NUCLEAR REGULATORY COMMISSION

Title: Advisory Committee on Reactor Safeguards
Plant License Renewal Subcommittee

MEETING OF THE PLANT LICENSE RENEWAL SUBCOMMITTEE

ACRS License Renewal Subcommittee Presentation
April 4, 2007

OI 3.0.3.3.2

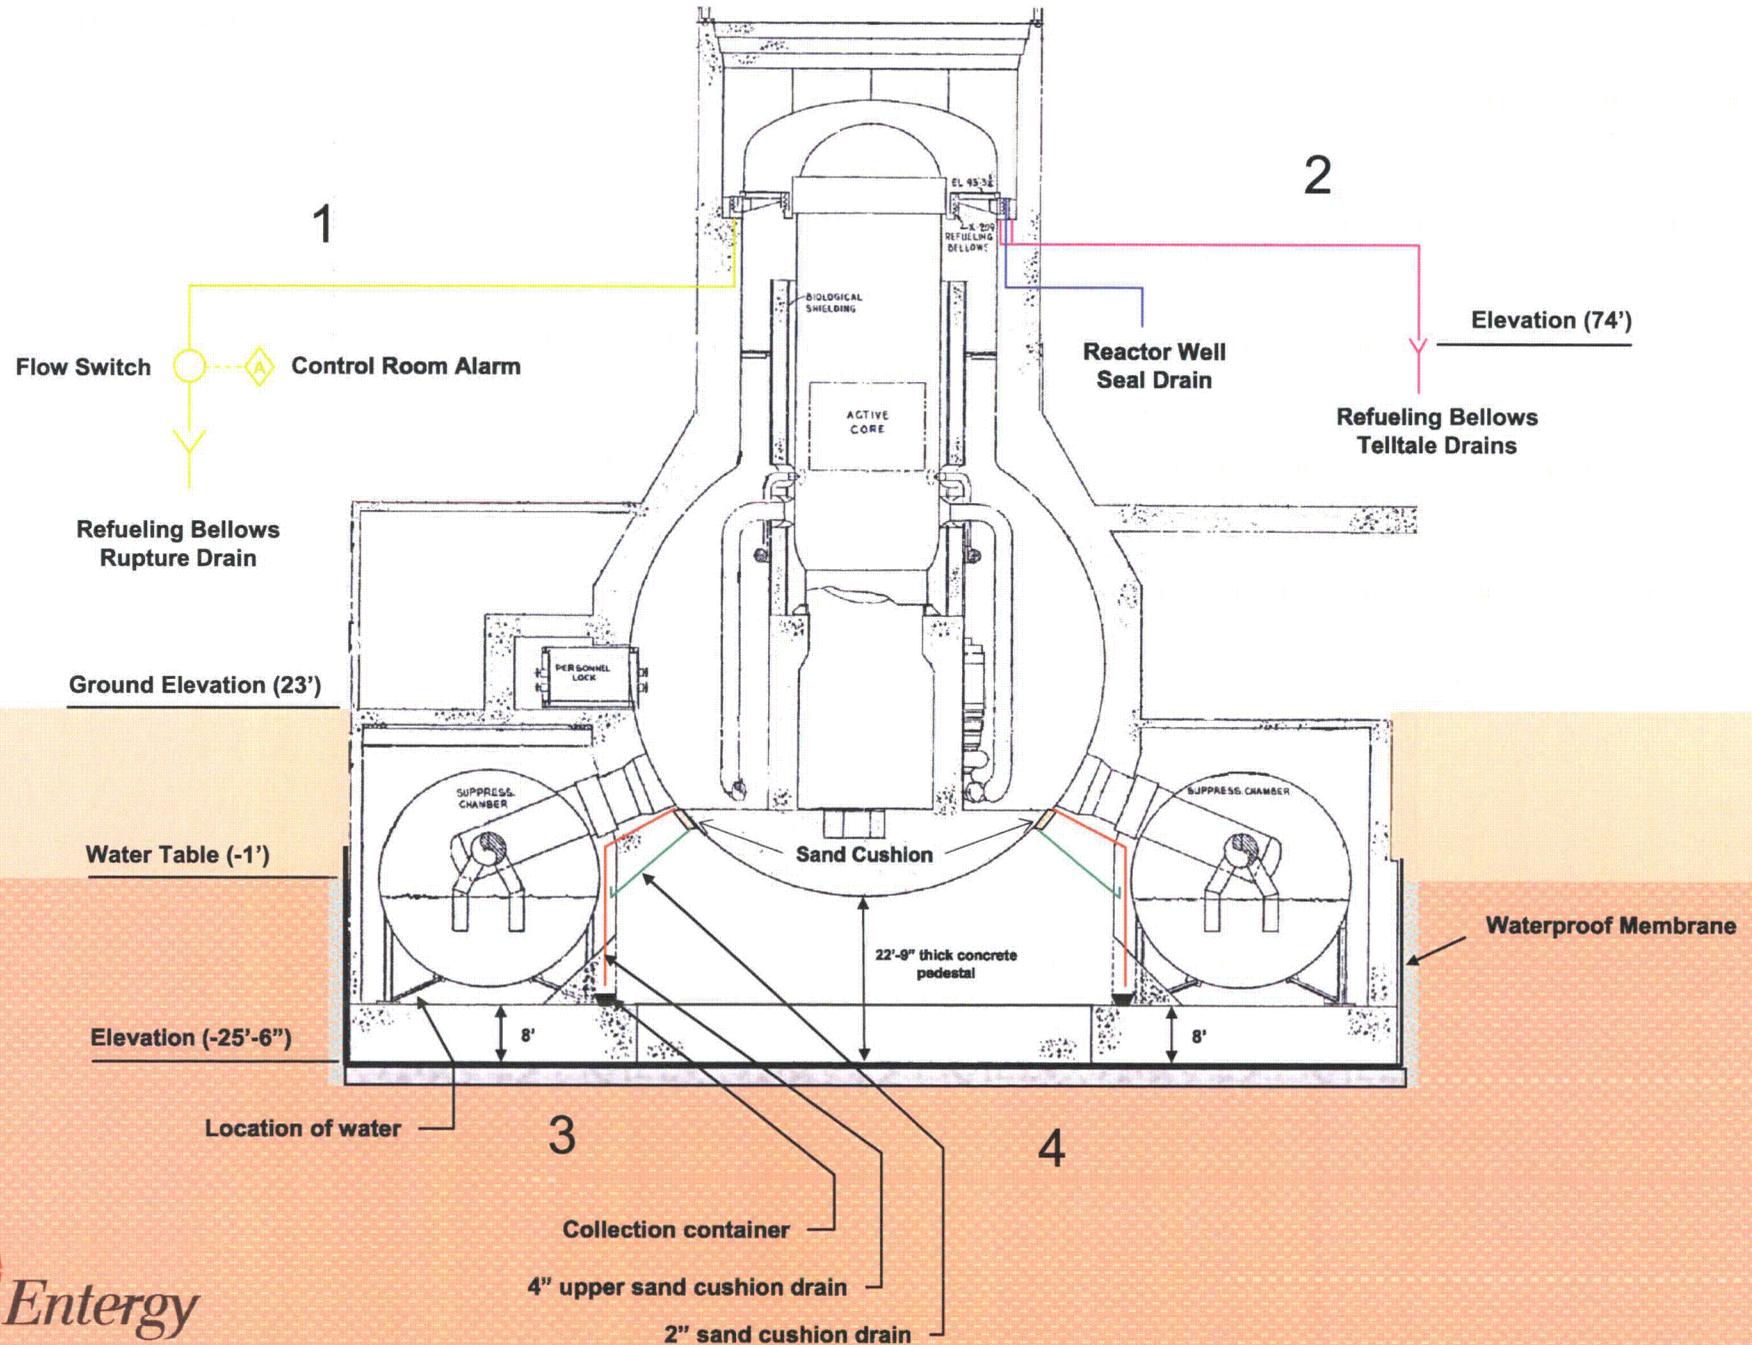
23 3: And the third item on which I'll spend
24 the most time is questions that were raised regarding
25 water on the torus room floor.

- Potential for corrosion in the inaccessible area of the steel containment shell, base mat and sand pocket region
- Inspection Observations
 - Rupture drain flow switch
 - Surveillance documentation
 - Torus room floor water

3" instrumented drain line alarms in control room

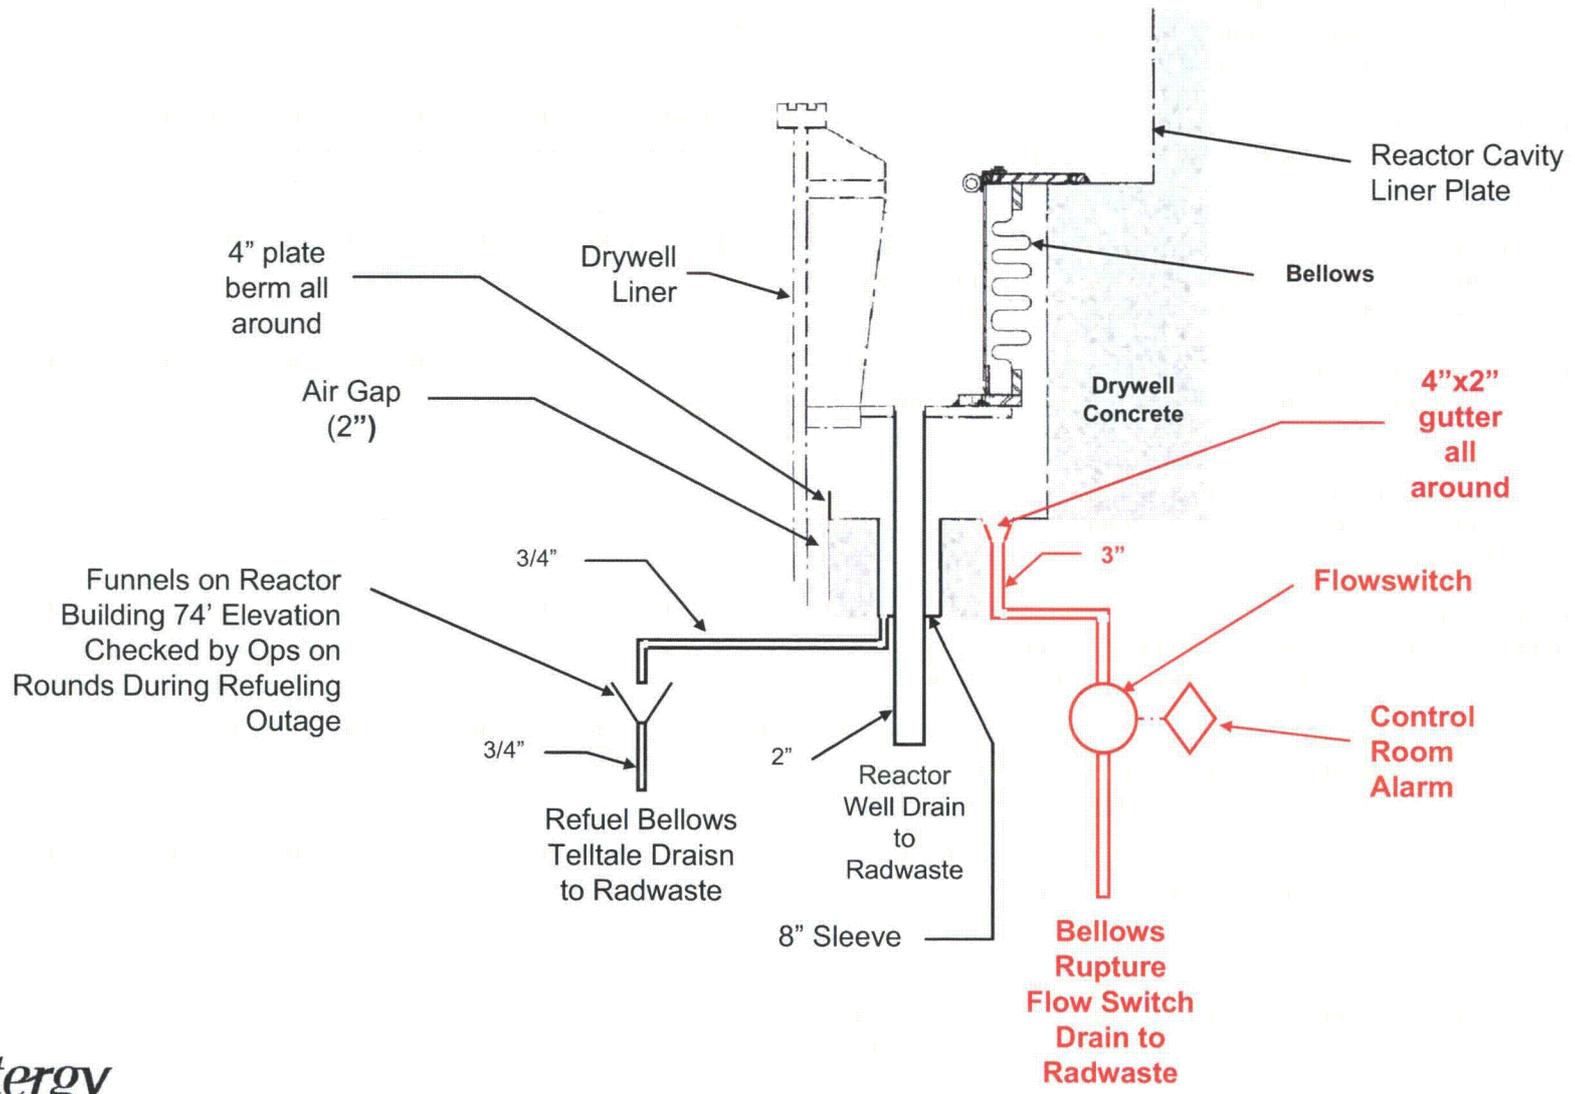
21 MEMBER BONACA: You said at the beginning
22 that the flow switch in the control room activates at
23 8 gpm. And a question I have for that system, I think
24 is a three-inch pipe, I guess it can -- going much
25 more than 6 gpm, right?

2 MR. BETHAY: We do a surveillance on it
3 every operating cycle to verify that there's flow and
4 that the flow switch is functional. And that's what
5 was identified in late 2005 that the flow switch
6 failed a surveillance.

Bay 10

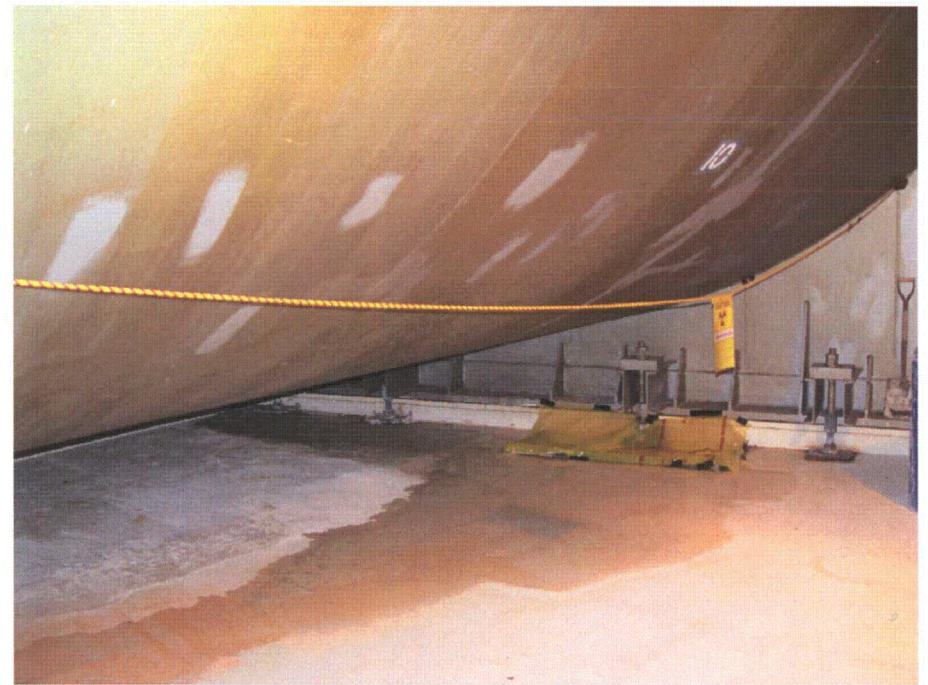
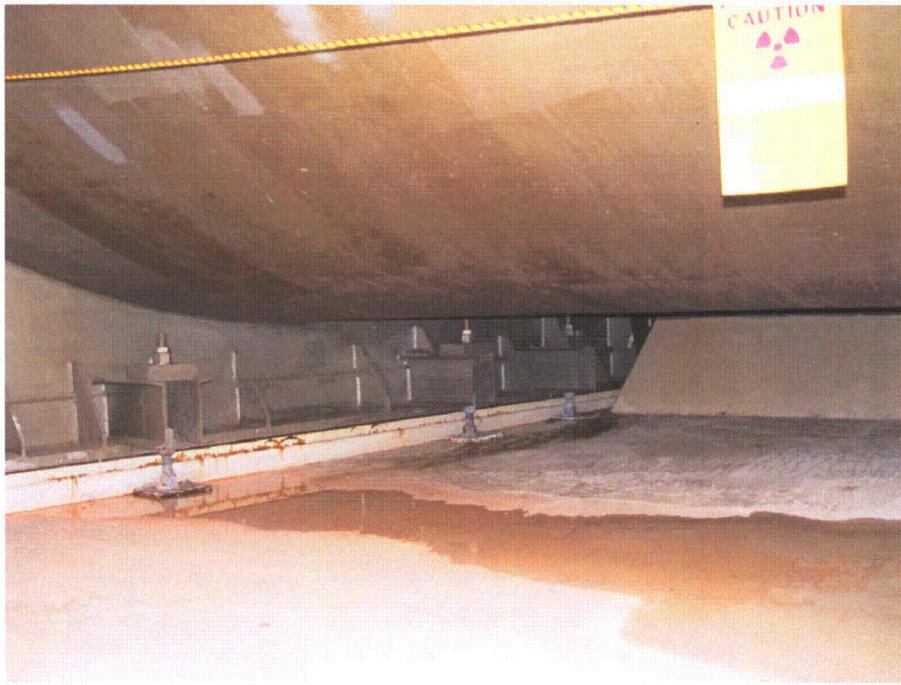
12 MR. BETHAY: As I mentioned, this became
13 a question in the regional inspection, but the
14 indications of water on the floor is not a new
15 phenomenon. There have been indications of water on
16 the torus room floor for a number of years. It's been
17 evaluated by engineering several times --

4 MR. BETHAY: No, sir. The water on the
5 floor just -- and let me go ahead and click to -- I'm
6 going to show you the worst picture. This is the
7 worst picture of the 16 torus bays.

7 MR. BETHAY: We'll be doing it right now.
8 Right. The maintenance request to do this is in the
9 planning stage. And it will look at a sampling of the
10 bolts in bay 10, because that's the worst. And then
11 we'll expand scope if necessary based on whatever we
12 find when we do that inspection.

19 That we'll verify the condition of the
20 bolts by sample in bay 10, is what we've lined out.
21 We'll do that prior to extended operation, and
22 actually that's --

Water on Torus Room Floor

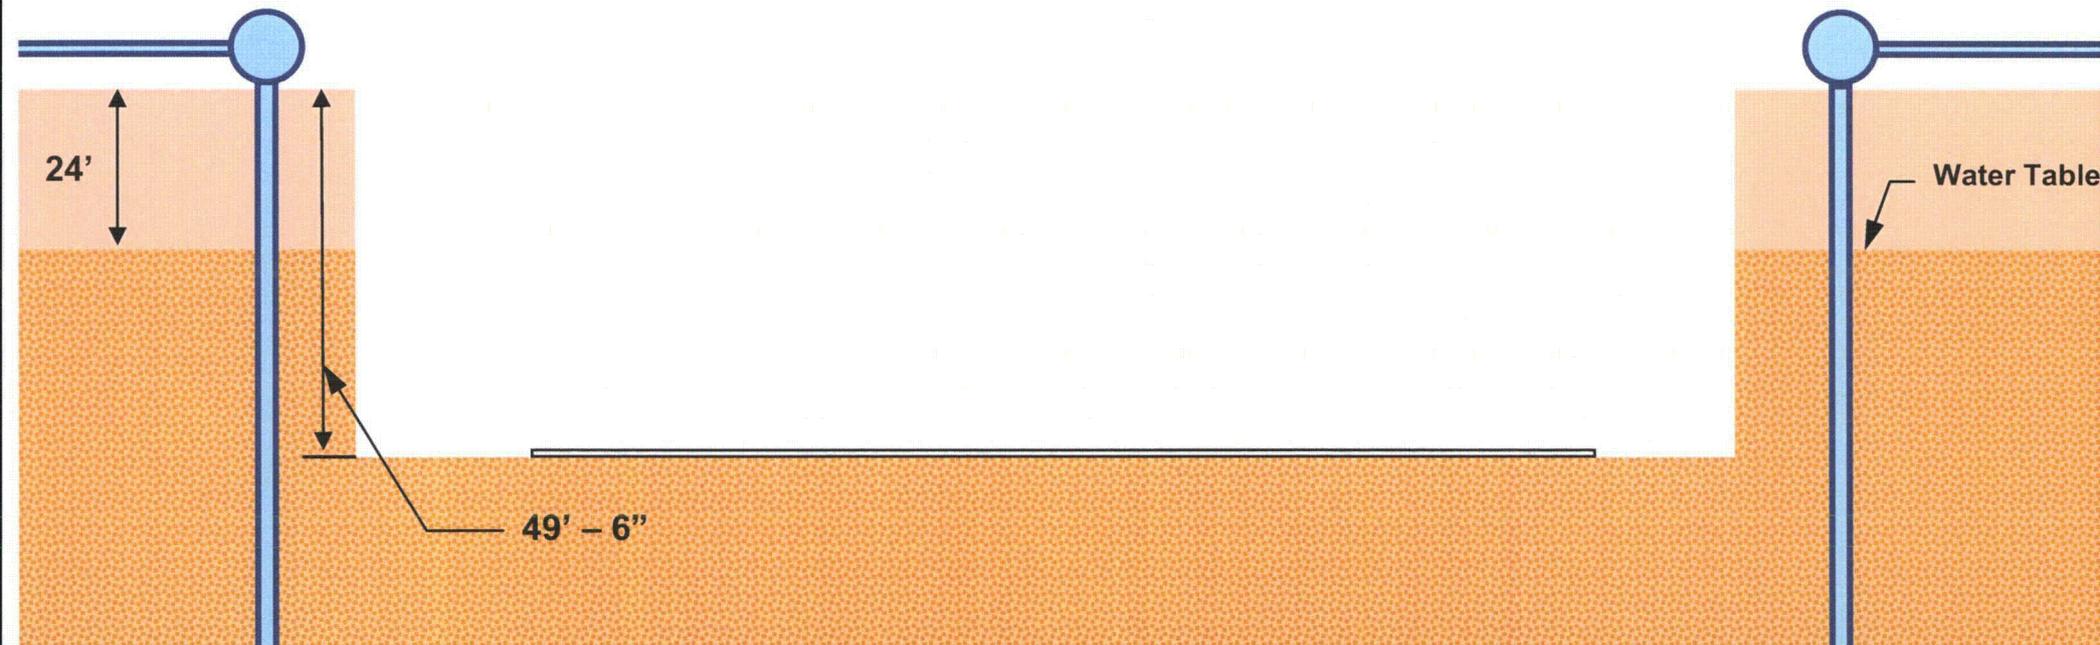
- Current Status
 - Water re-analyzed to demonstrate non aggressiveness.
 - Review over last 6-weeks shows minimal water on torus floor.
 - Seepage, mostly in Bay 10 estimated at $\frac{1}{4}$ " to $\frac{1}{2}$ " over 100 square feet.
 - Independent Assessment to demonstrate full functional capability of torus base-mat conducted.
 - Professor Franz Ulm of MIT's Department of Civil Engineering
